ADDENDUM 1

UNC Charlotte Friday Renovation
Charlotte, NC
C DESIGN Project No.: 0604-0749
Issue to: All Registered Planholders

OWNER/CLIENT/TENANT: UNC Charlotte
Contract Document Date: April 20, 2026
Addendum Date: May 07, 2026

G3.00

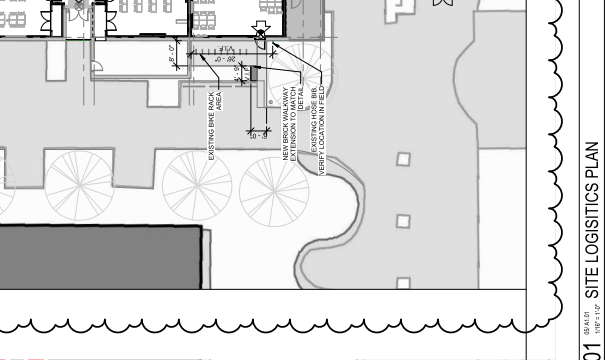
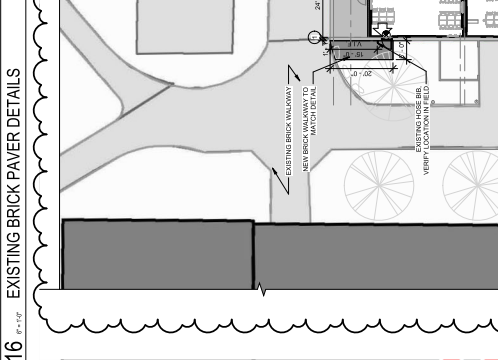
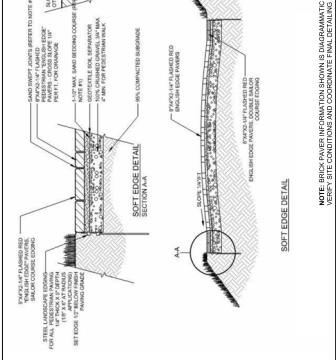
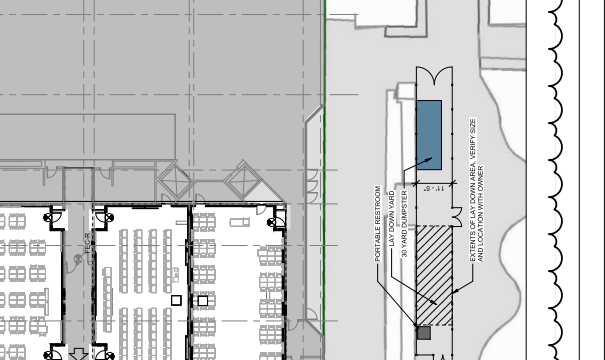
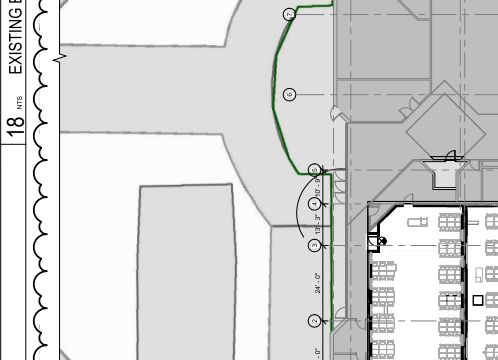
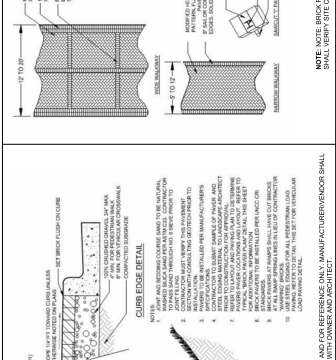
1. Revised Sheet G3.00 – SITE LOGISTICS PLAN
 - a. Site background has been updated to reflect current conditions. Extents of brick pavers and other miscellaneous site conditions have been clarified per RFI Log dated 05/07/2026.

AD1.01

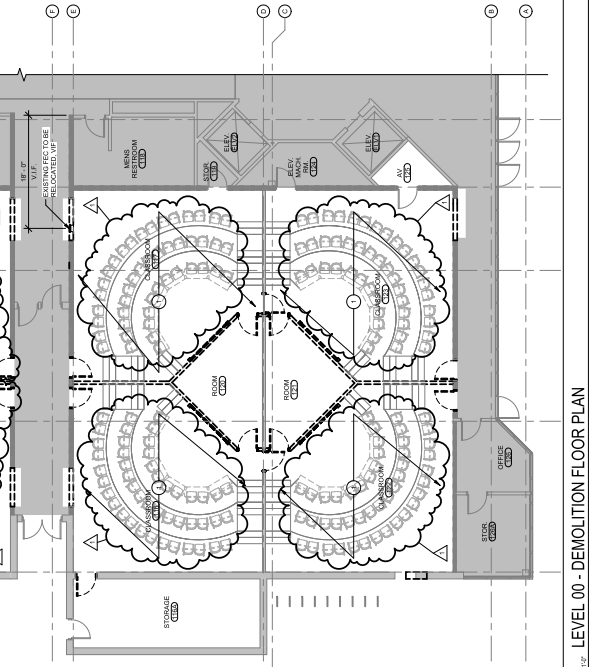
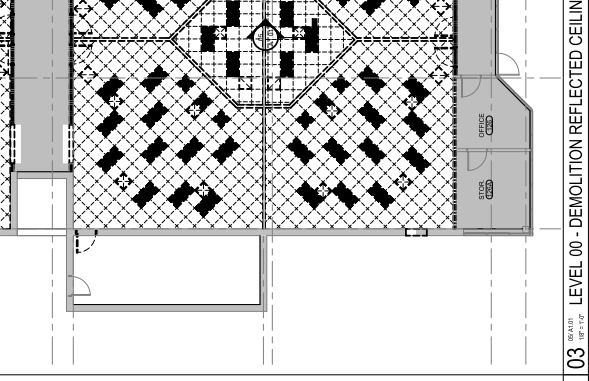
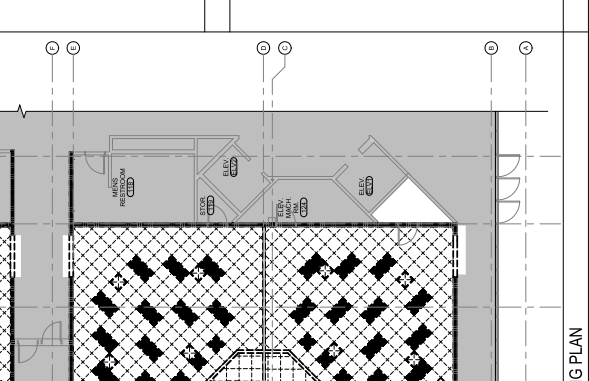
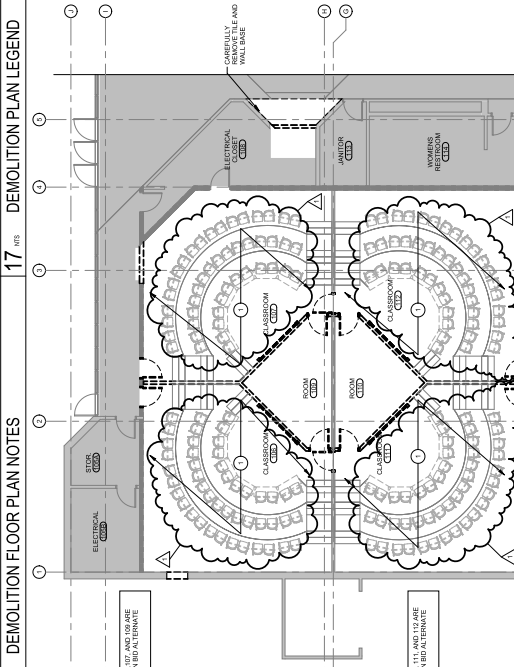
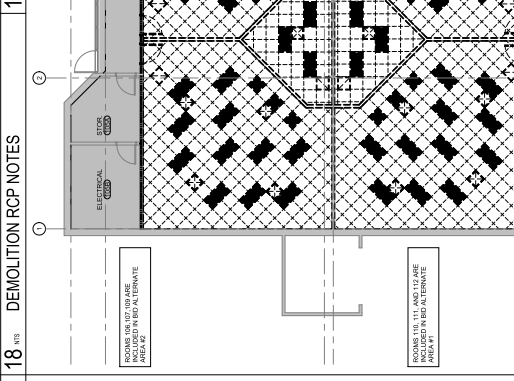
- a. GC demolition scope clarified, notes have been added for specific GC removal and relocation items per RFI Log dated 05/07/2026.
 - 7. Revised Sheet M1.01 – DUCTWORK AND PIPING - LEVEL 01 - DEMOLITION AND NEW WORK PLAN

BID ALTERNATE CLARIFICATION

- ROOMS 106, 111, 107, 108, 109, 110, 111, 112, 113, 114, 115, 116, 117, 118, 119, 120, 121, 122, 123, 124, AND 125 ARE INCLUDED IN THE BID.
- ROOMS 101, 102, 103, 104, 105, 106, 107, 108, 109, 110, 111, 112, 113, 114, 115, 116, 117, 118, 119, 120, 121, 122, 123, 124, AND 125 ARE INCLUDED IN BID ALTERNATE AREA 2.

M1.01

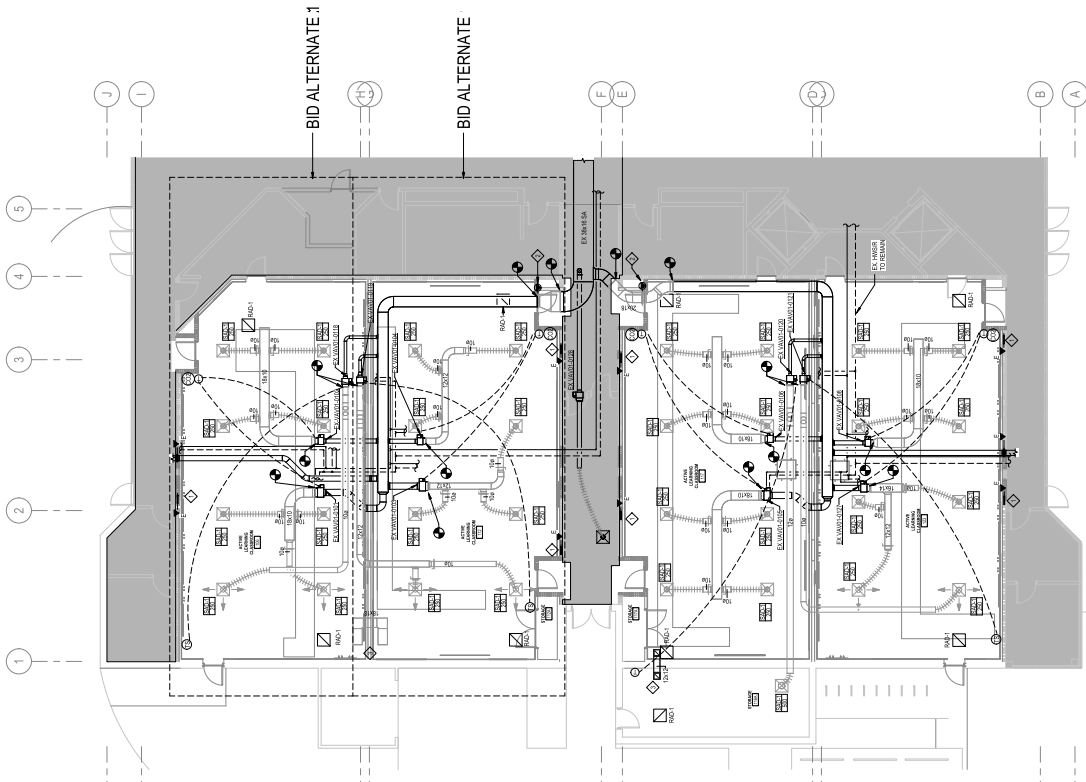
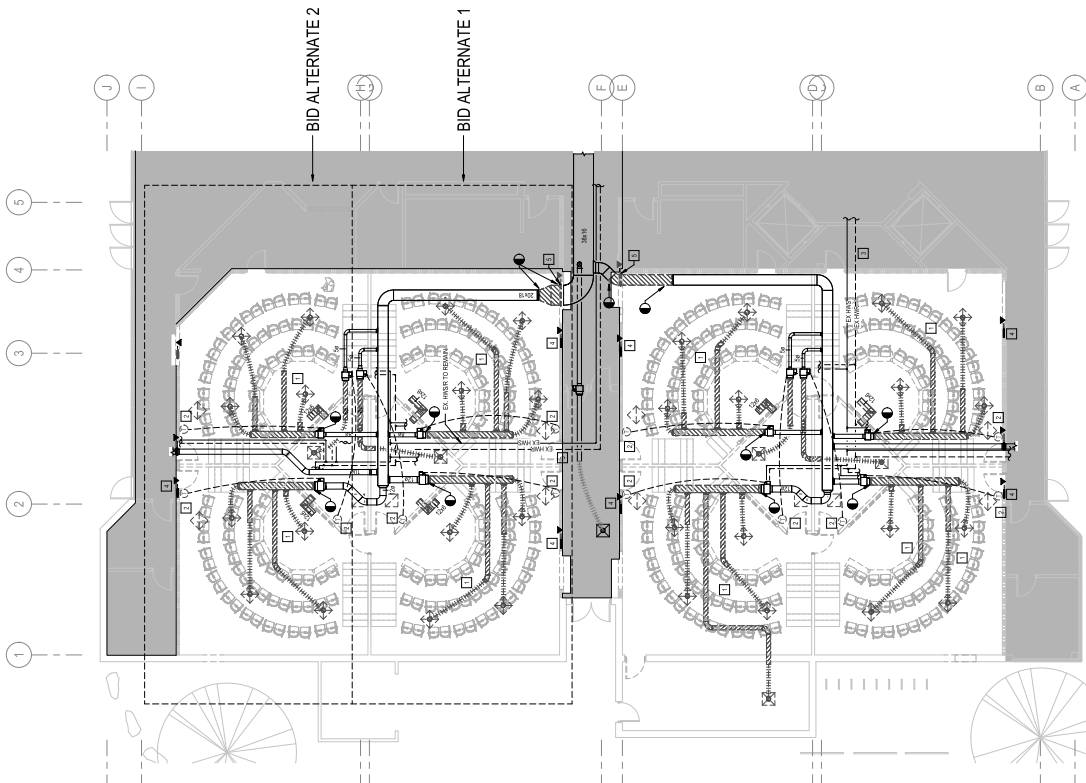
- a. Bid alternate scope clarified per RFI Log dated 05/07/2026.
 - 8. Revised Sheet E1.00 – ELECTRICAL - LIGHTING LEVEL 01 - DEMOLITION PLAN
 - a. Bid alternate scope clarified per RFI Log dated 05/07/2026.

E1.01

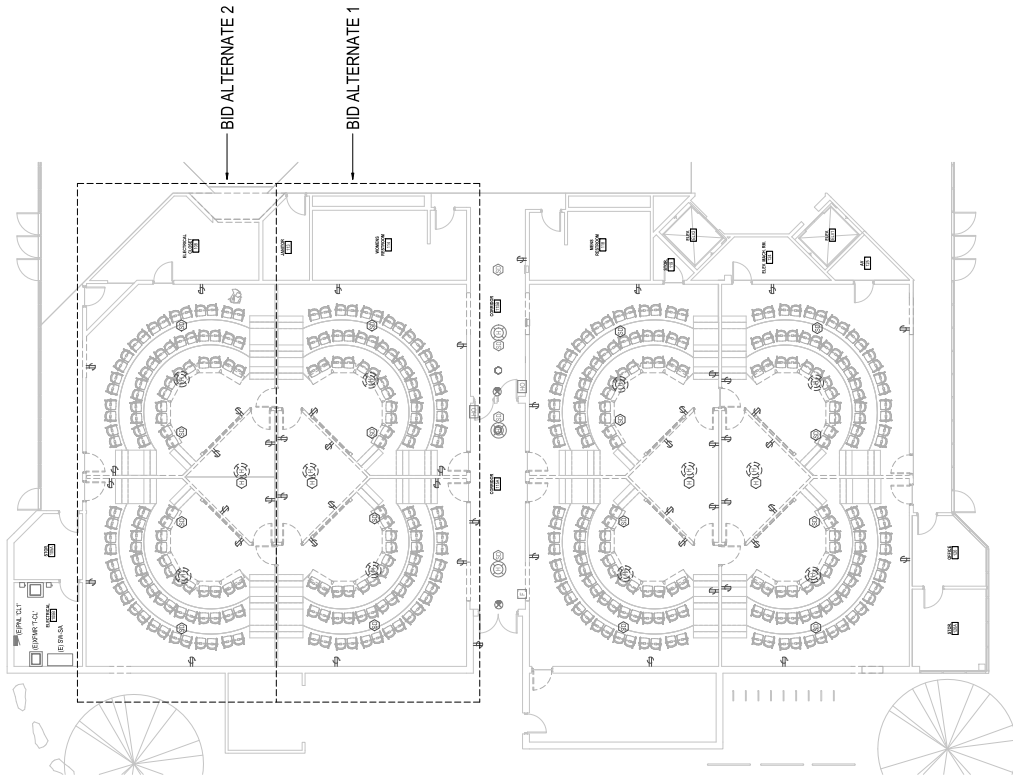
- 9. Revised Sheet E1.01 – ELECTRICAL - POWER SPECIAL SYSTEMS - LEVEL 01 - DEMOLITION PLAN
 - a. Bid alternate scope clarified per RFI Log dated 05/07/2026.

E2.00

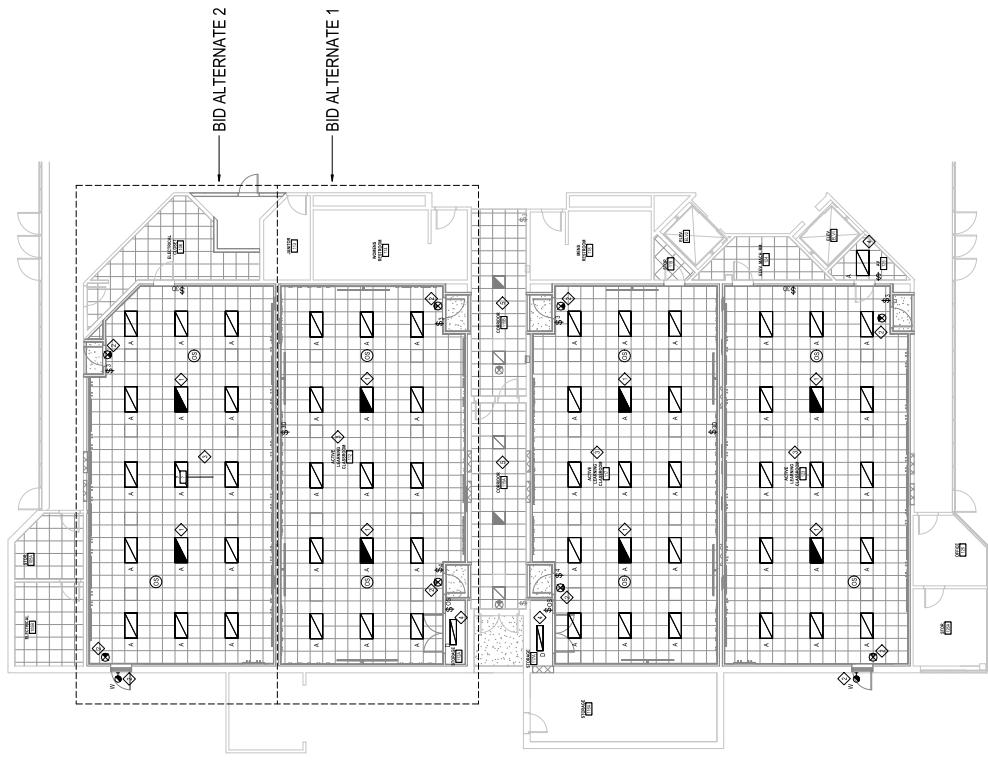
- 10. Revised Sheet E2.00 – ELECTRICAL - LIGHTING - LEVEL 01 - NEW WORK PLAN
 - a. Bid alternate scope clarified per RFI Log dated 05/07/2026.
 - 11. Revised Sheet E2.01 – ELECTRICAL - POWER - LEVEL 01 - NEW WORK PLAN

E2.02

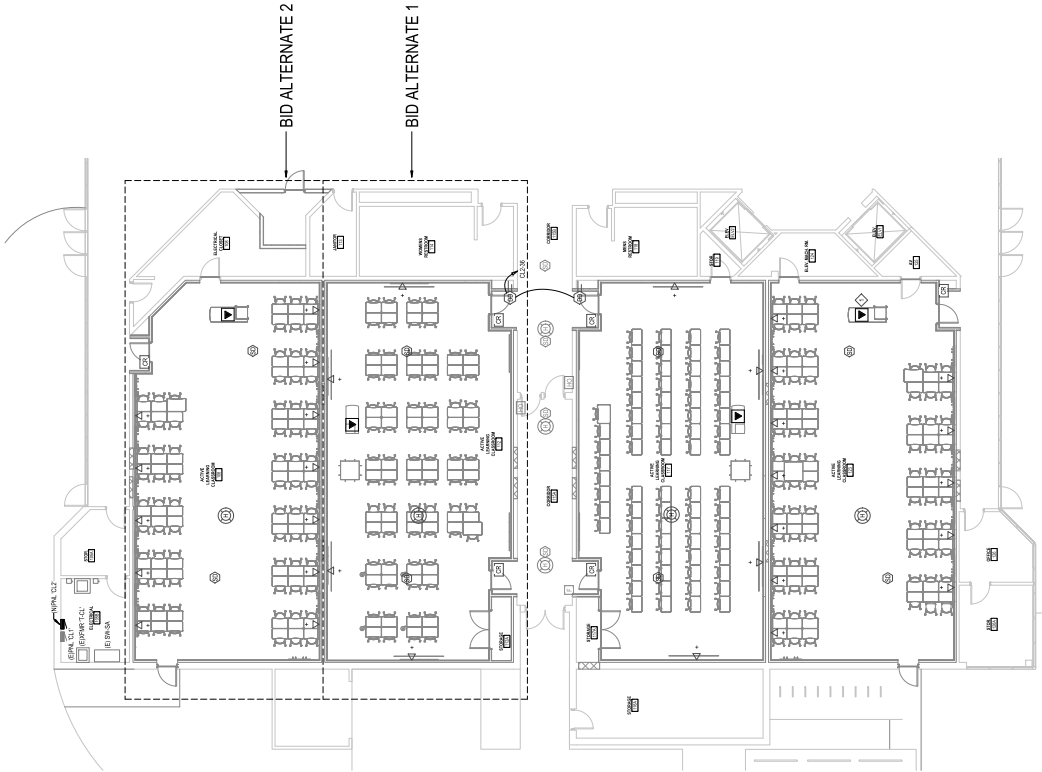
- a. Bid alternate scope clarified per RFI Log dated 05/07/2026.
 - 12. Revised Sheet E2.02 – ELECTRICAL - SPECIAL SYSTEMS - LEVEL 01 - NEW WORK PLAN
 - a. Bid alternate scope clarified per RFI Log dated 05/07/2026.
